1970 - 1973 Corvette: Service Bulletin: Overheating - 454 Cu.In. Engine with Air Conditioning

73-T-28

Subject: ENGINE OVERHEAT - 1970-1973
CORVETTES WITH 454 CU. IN.
ENGINES AND AIR CONDITIONING

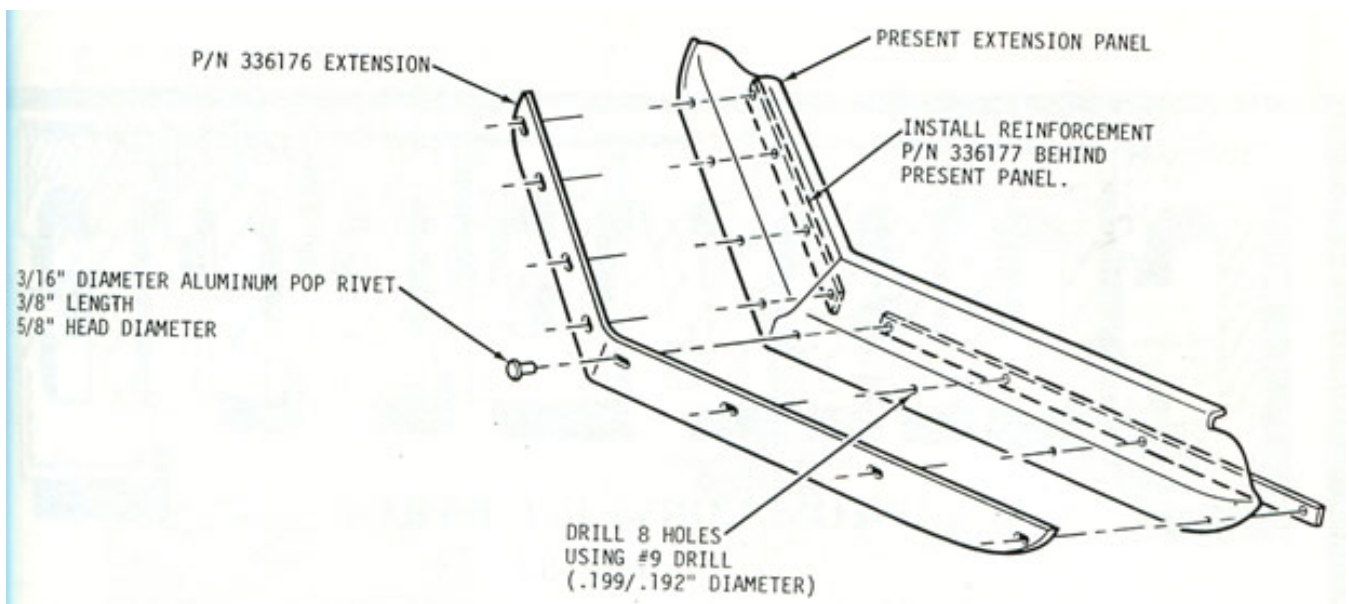
To improve low speed cooling, an additional grille panel lower extension was installed in 1973 Corvettes produced after Vehicle Identification Number 1Z37Z3S410722. This extension, Part Number 336176, may be installed as illustrated on page 2 of this bulletin on early 1973 Corvettes only.
